Product Change Notification / ASER-19HIWO872

CCB 4748 Final Notice: Qualification of MTAI as an additional assembly site for selected ATMEGA324PBxxx and PIC16F1xxx device families available in 44L TQFP (10x10x1mm) package.

CCB 4748
Pre and Post Change Summary
PCN #: ASER-19HIWO872

Lead Frame Comparison

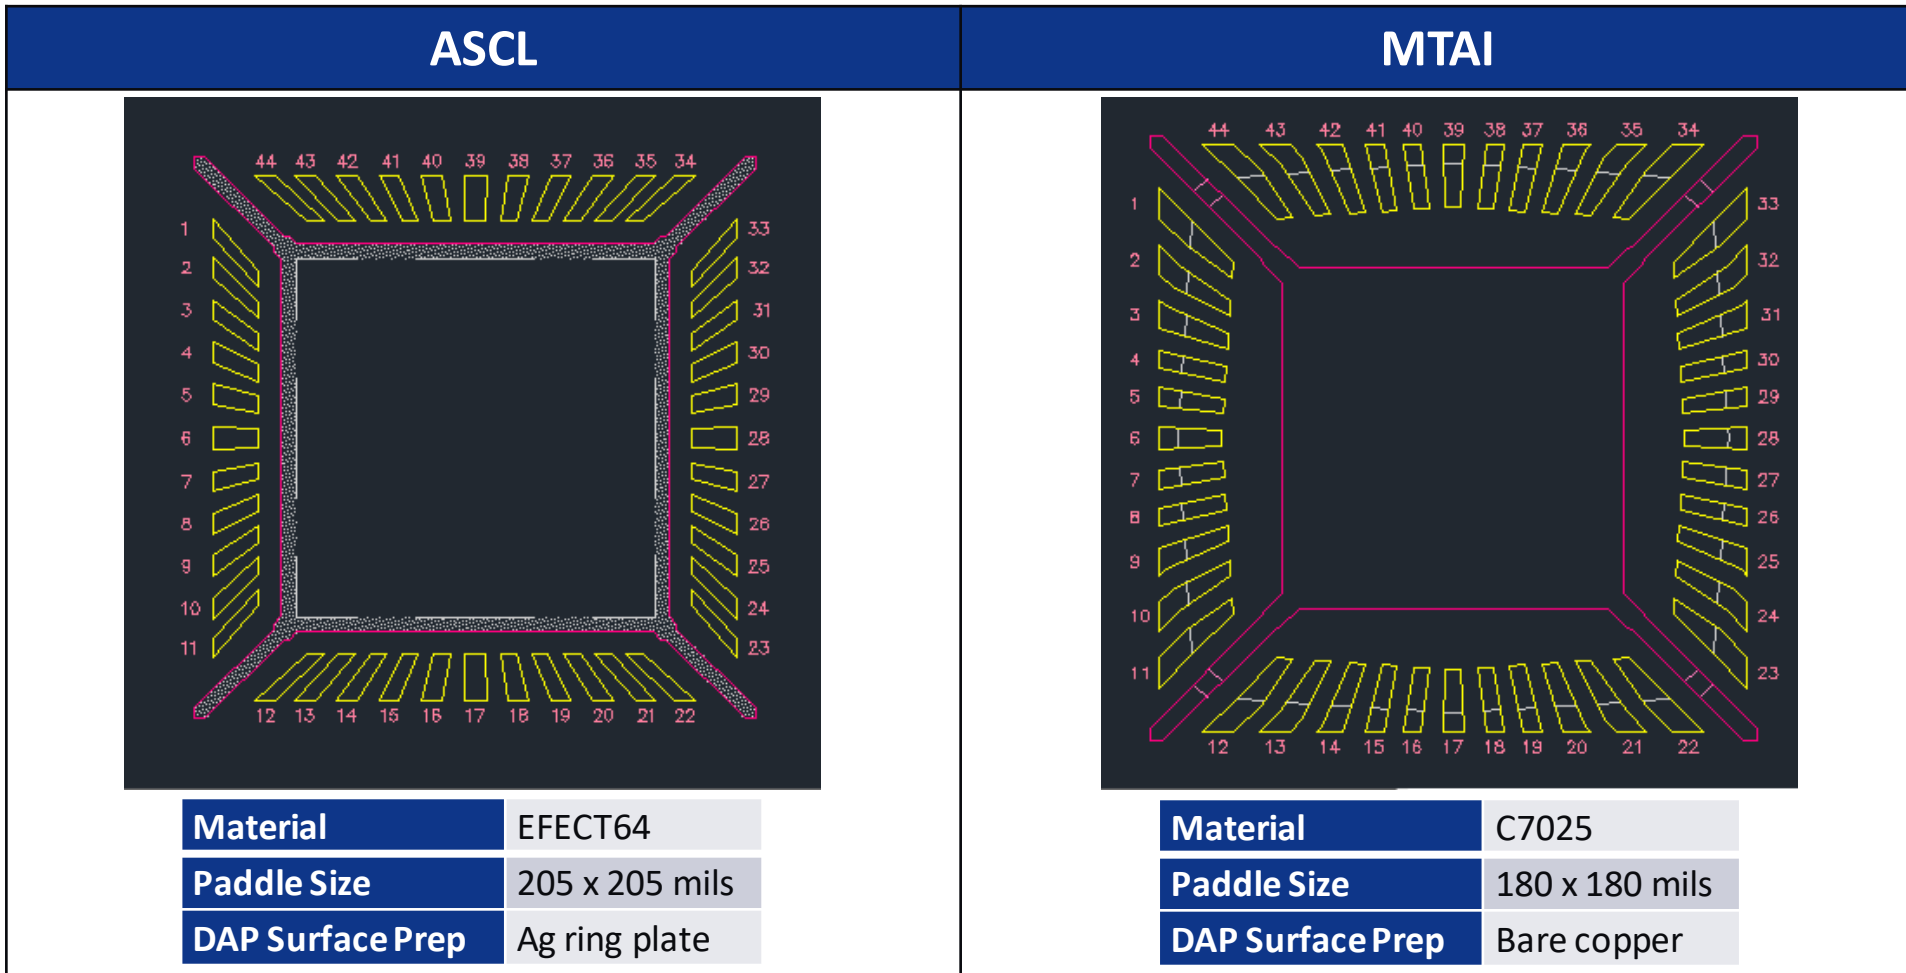
Assembly Site		ASE Group Chung-Li (ASCL)	ASE Group Chung-Li (ASCL)	Microchip Technology Thailand (MTAI)
Moisture Sensitivity Level (MSL)		MSL3	MSL3	MSL1
Shipping Media	Tray	Blue Bakeable	Blue Bakeable	Dark Blue Non-bakeable
	T/R	No Change	No Change	No Change
Wire Material		Au/CuPdAu	Au/CuPdAu	Au
Die Attach Material		EN-4900GC	EN-4900GC	3280
Molding Compound Material		G700	G700	G700
Lead Frame	Material	EFFECT64	EFFECT64	C7025
	Paddle Size	205 x 205 mils	205 x 205 mils	180 x 180 mils
	DAP Surface Prep	Ag ring plate	Ag ring plate	Bare Copper
	See Pre and Post Change Summary for Lead Frame comparison.
